Woolworths Regional Distribution Centre

11 Warren Road, Warnervale
NSW 2259

Access Review – DA 3 (Final)

24 March 2022

MAIN OFFICE AND AMENITIES FLOOR PLAN - LEVEL 2
SCALE: 1 : 100

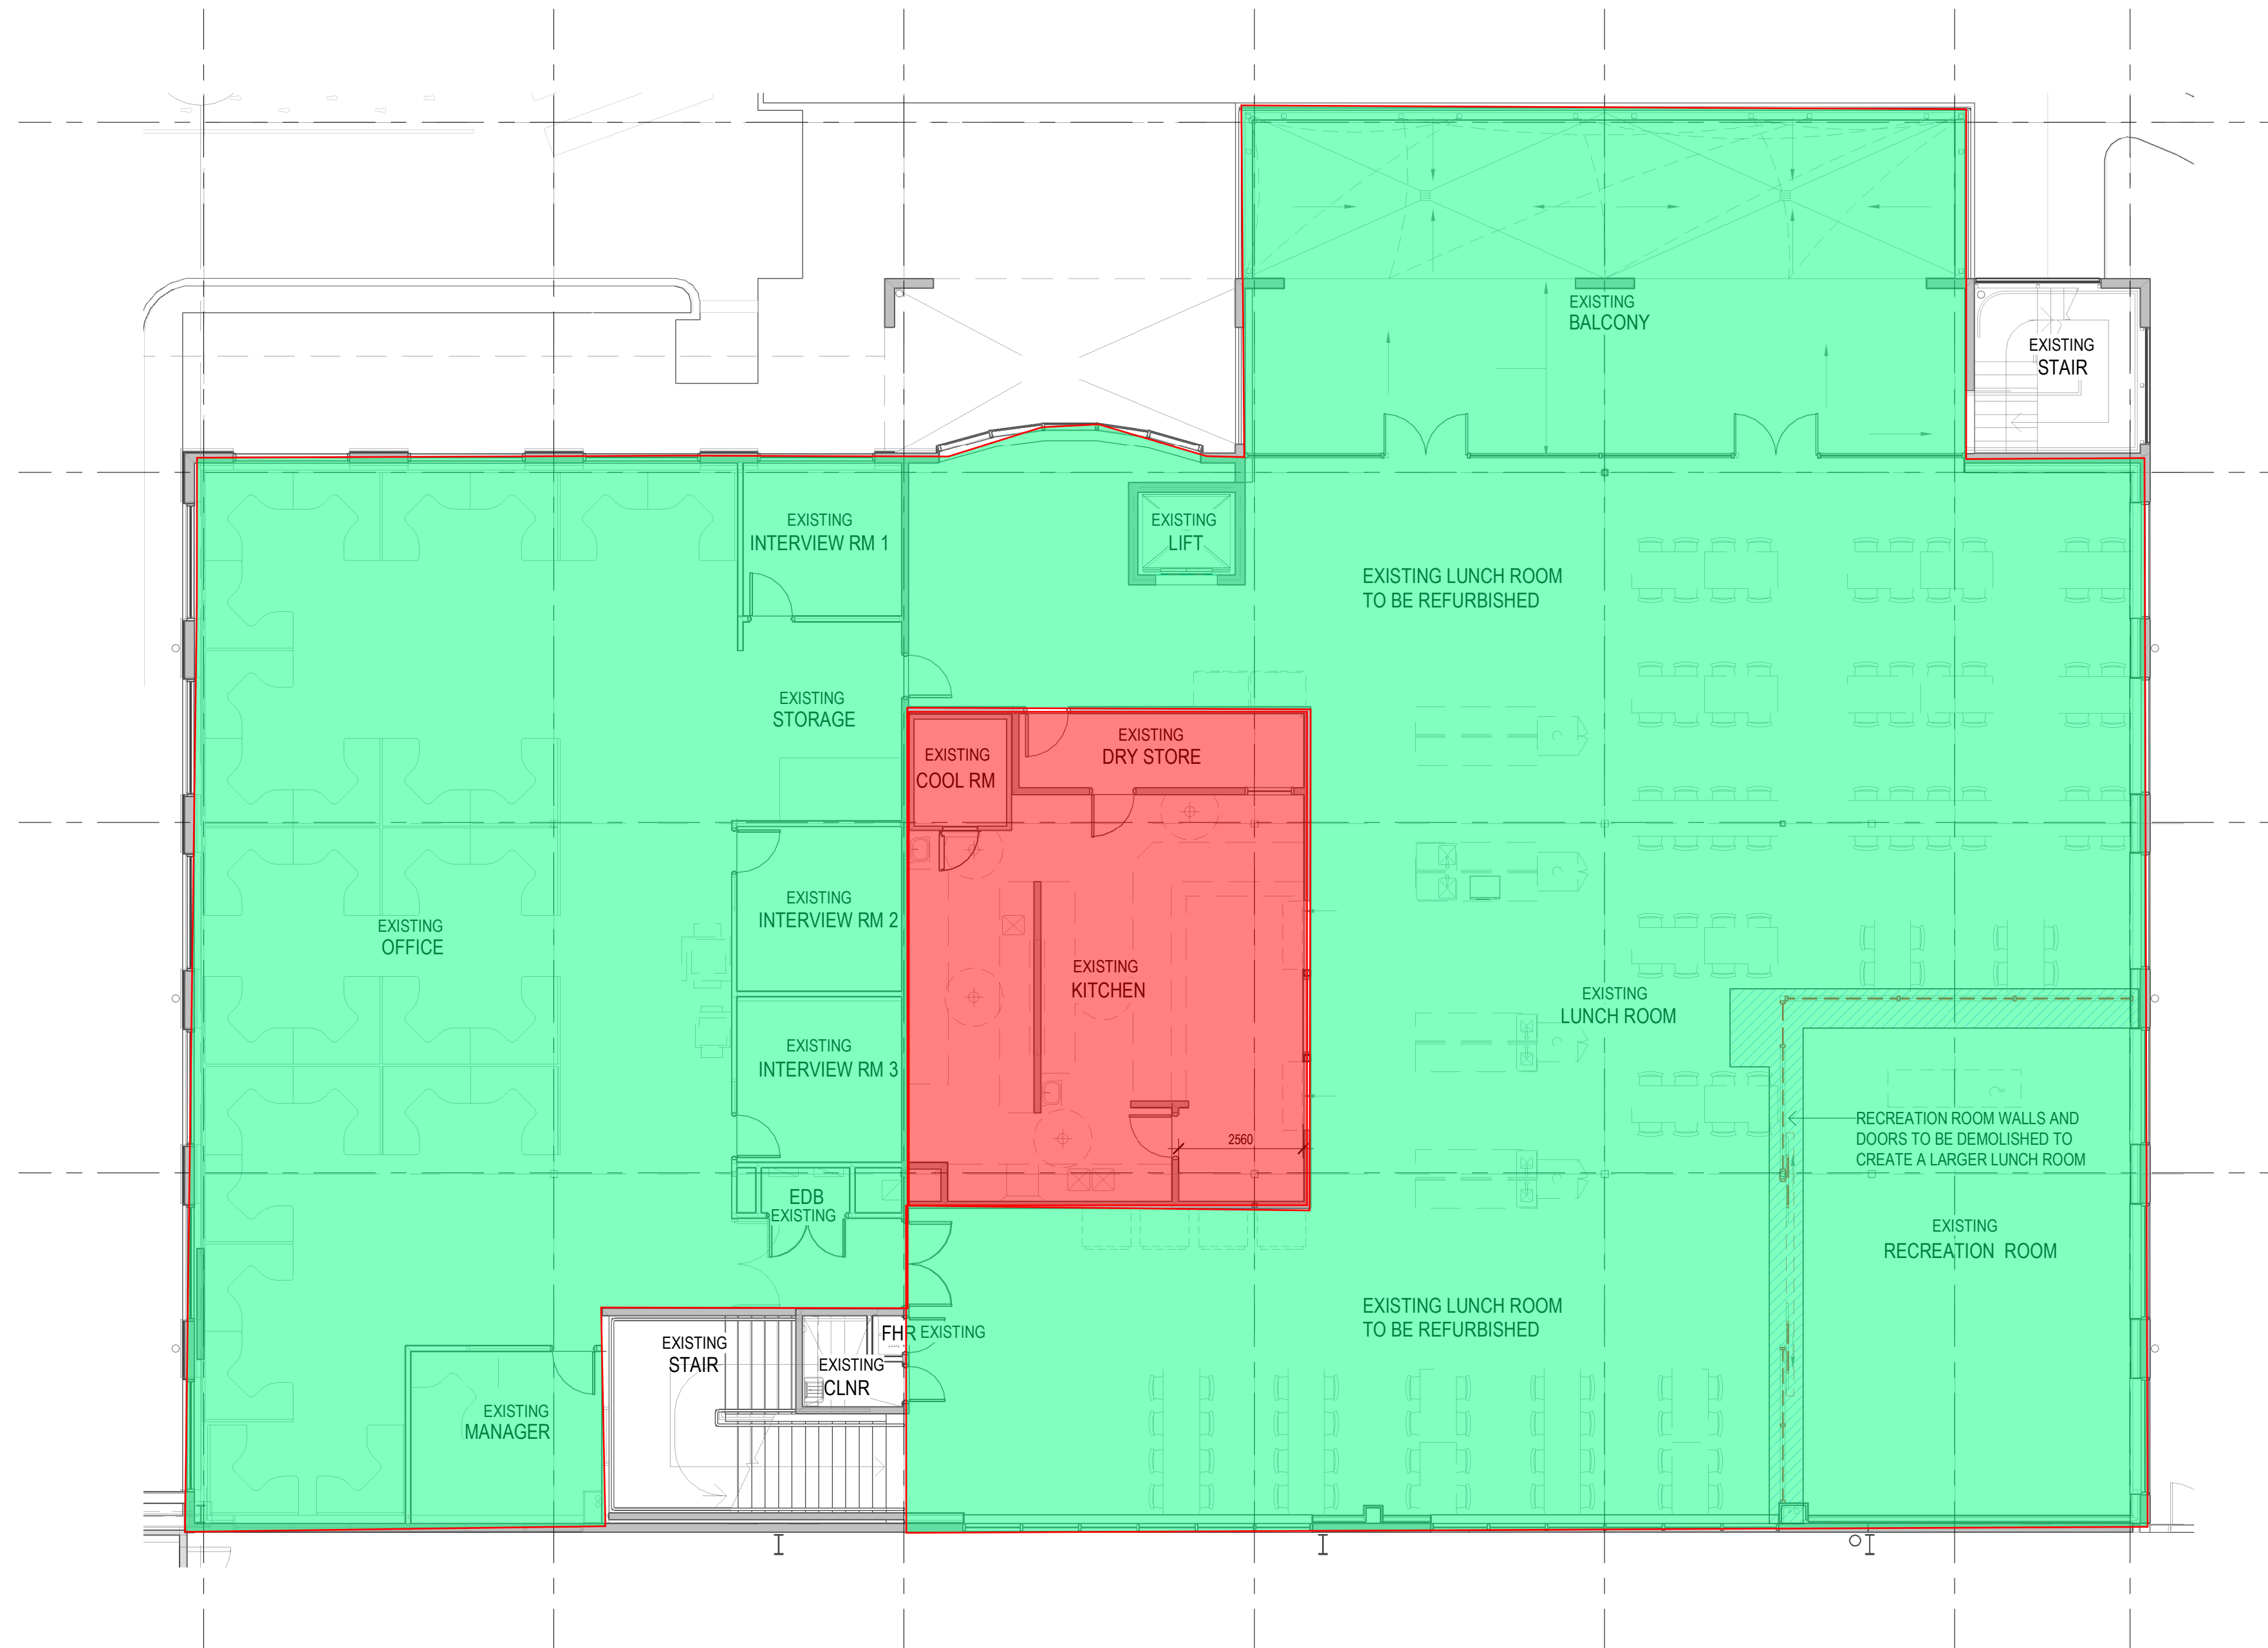
fully accessible areas for staff
visitors would need to be escorted in
these areas

non-accessible - unsafe work
environment / no safe paths of travel

Areas not required to be accessible.
BCA D3.4 Exemption is applicable for areas that poses the health and safety risks for persons with disability, or where access is inappropriate because of the particular purpose and use of the area.
Due to the particular use of these areas being storage and distribution, and the health and safety risks it poses for persons with disability, it is noted access is limited to the green zone and the red zones can be D3.4 exempt.
Consult PCA also.

TITLE:
**TC AND AMBIENT OFFICE AREAS
LEVEL 2 PLANS**

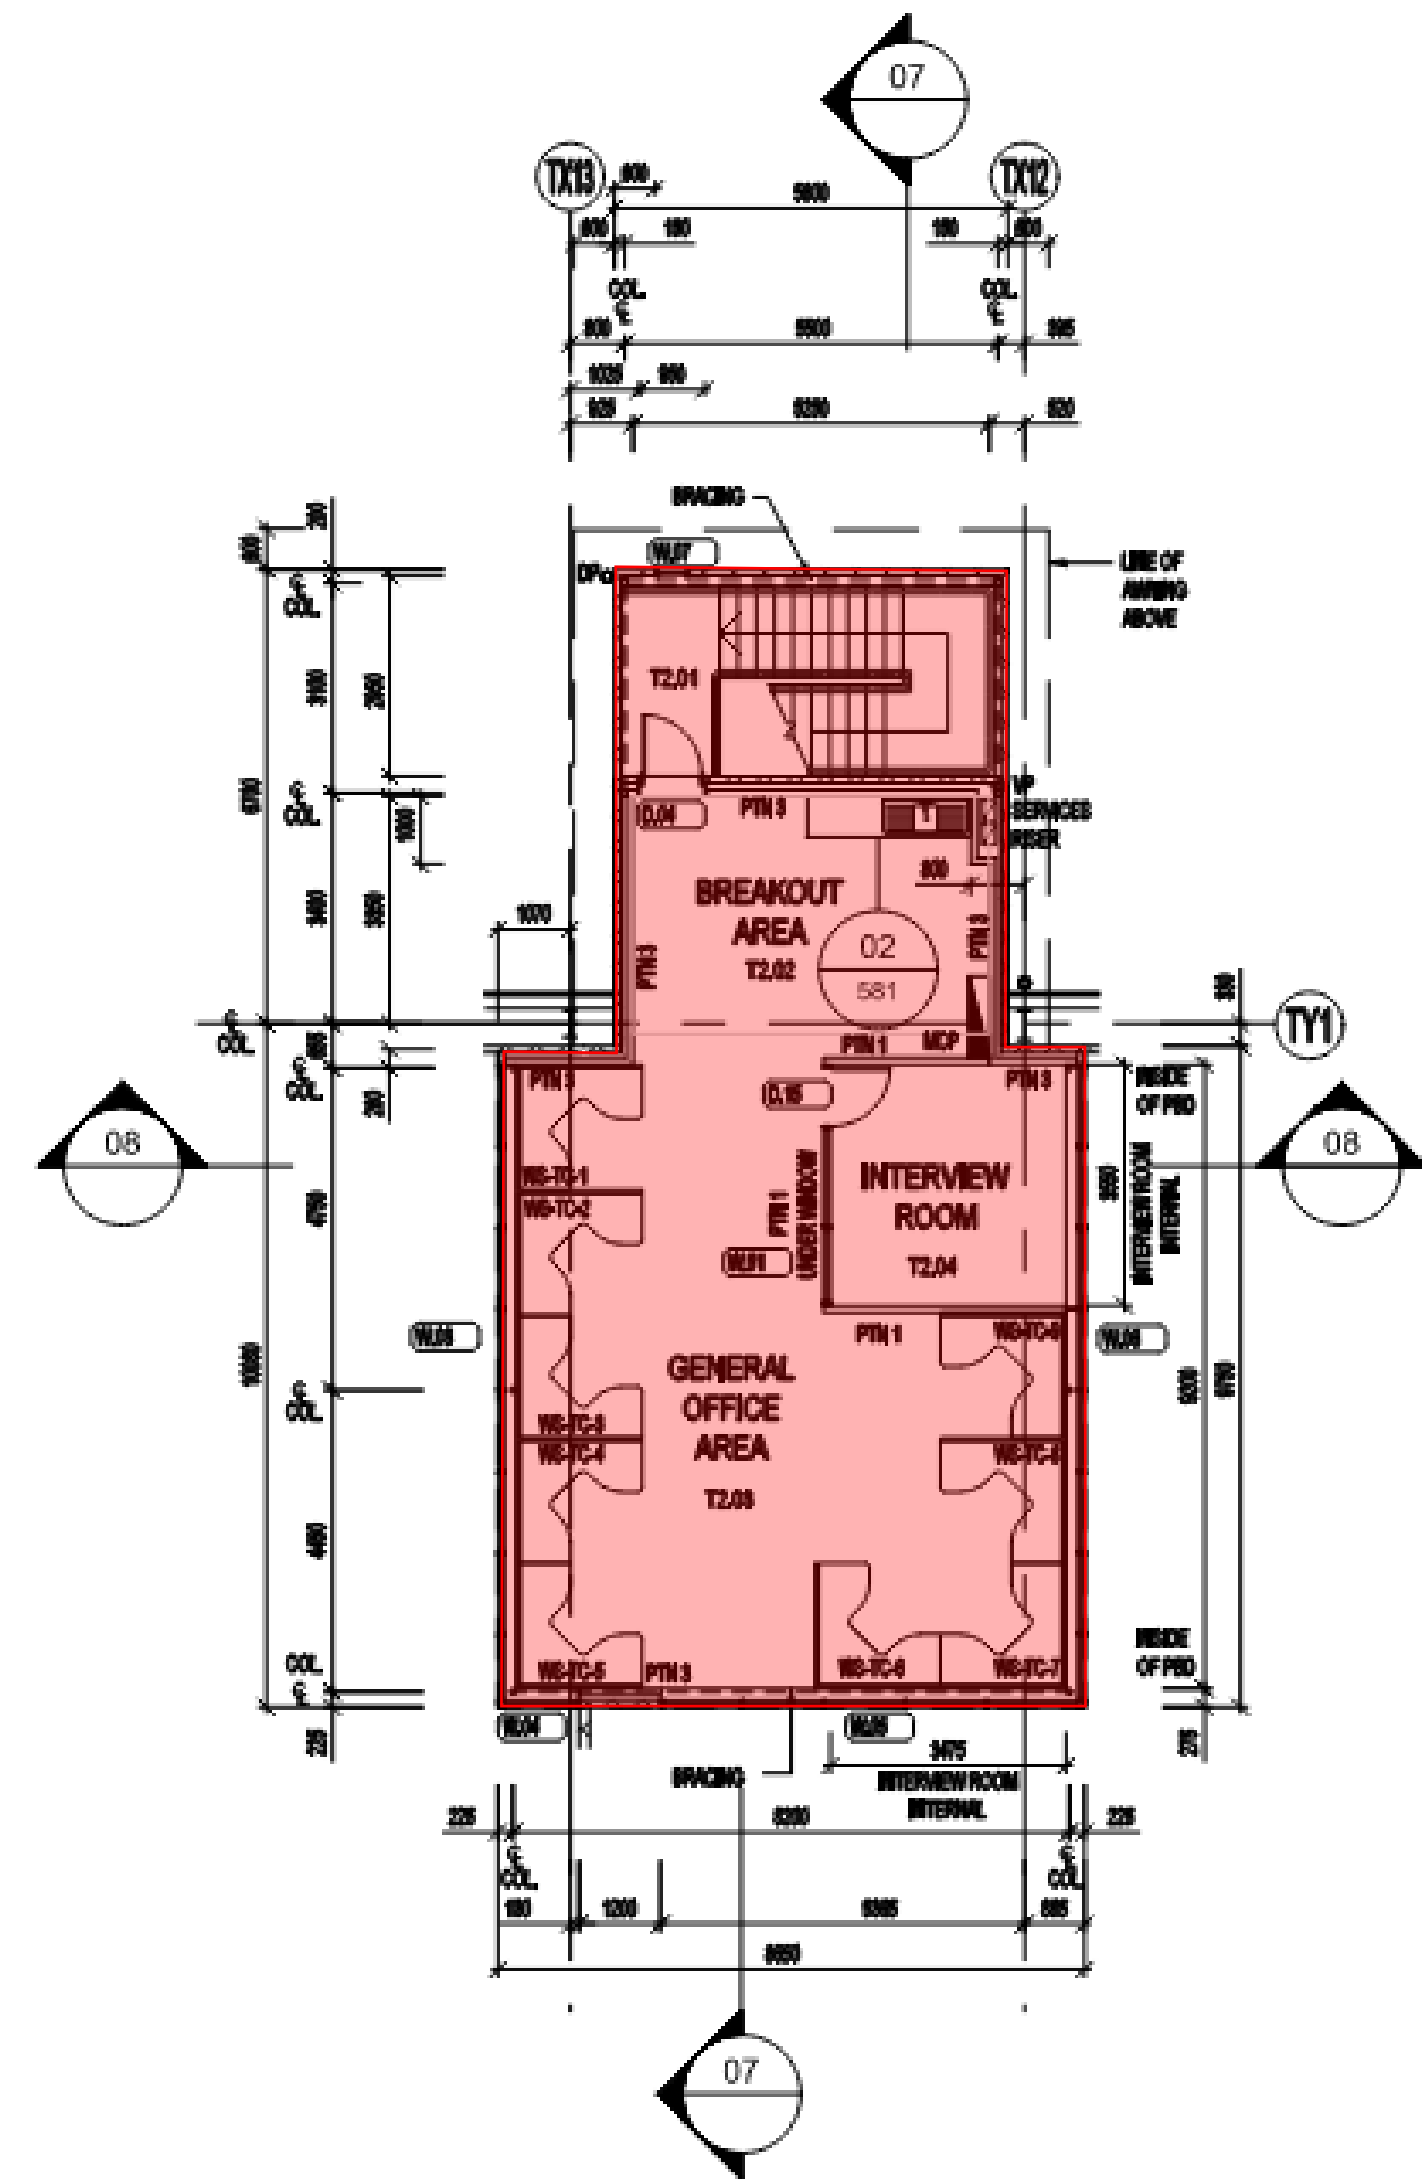
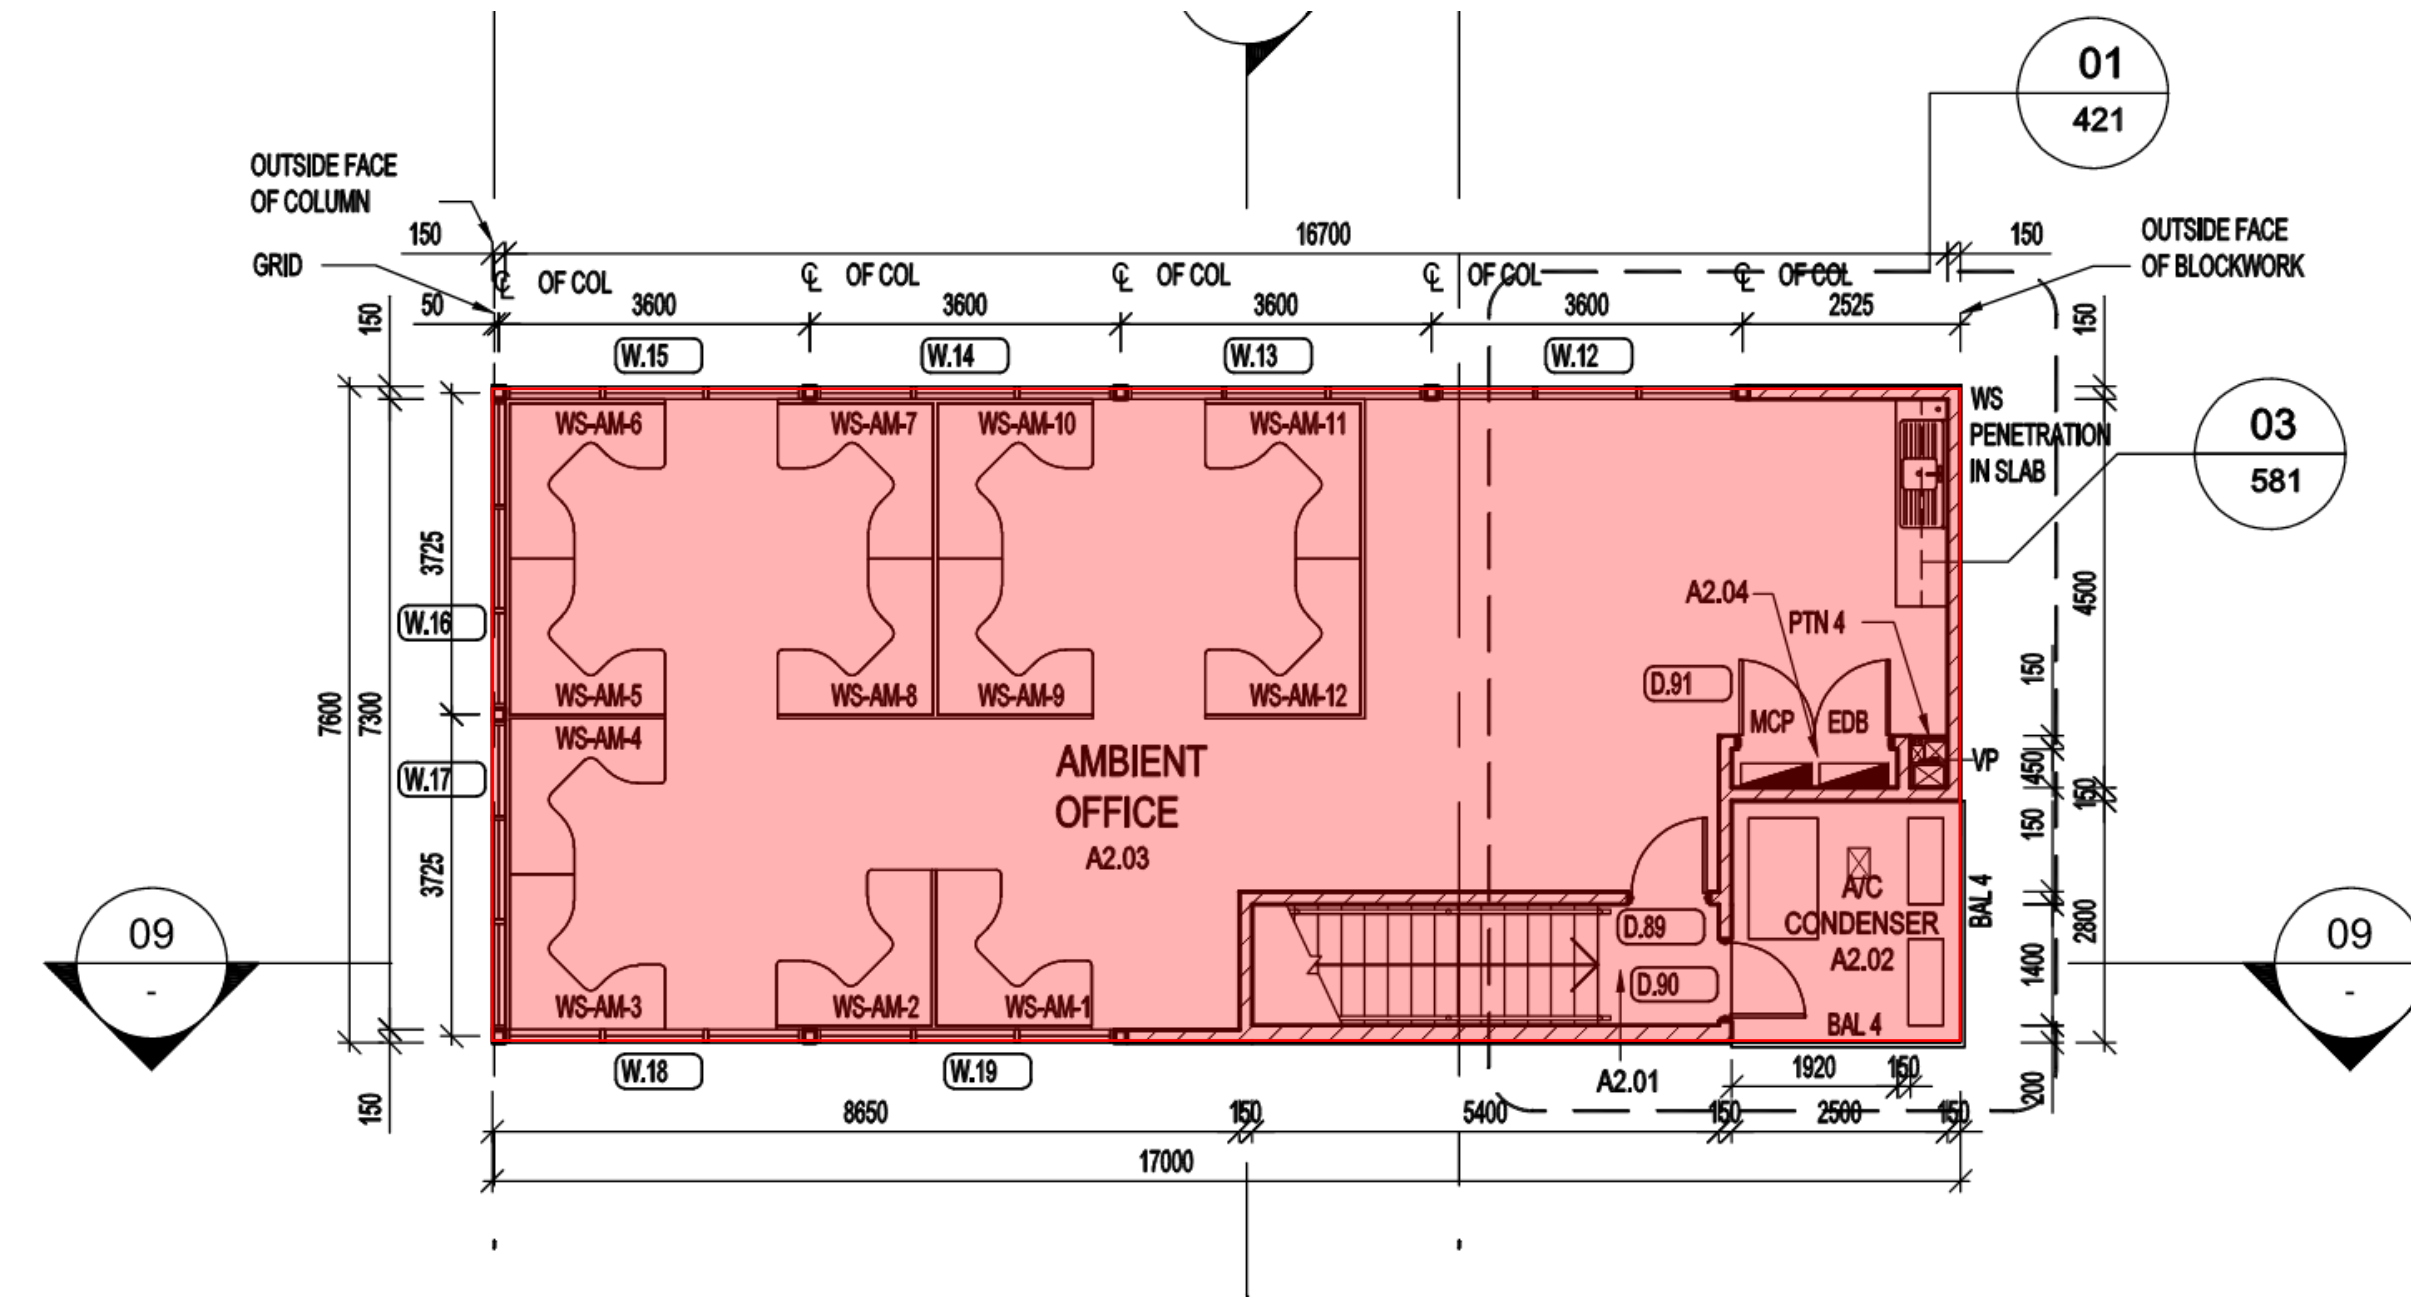
Areas not required to be accessible.

BCA D3.4 Exemption is applicable for areas that poses the health and safety risks for persons with disability, or where access is inappropriate because of the particular purpose and use of the area.

Due to the particular use of these areas being storage and distribution, and the health and safety risks it poses for persons with disability, it is noted access is limited to the green zone and the red zones can be D3.4 exempt.

Consult PCA also.

fully accessible areas for staff
visitors would need to be escorted in
these areas

non-accessible - unsafe work
environment / no safe paths of travel
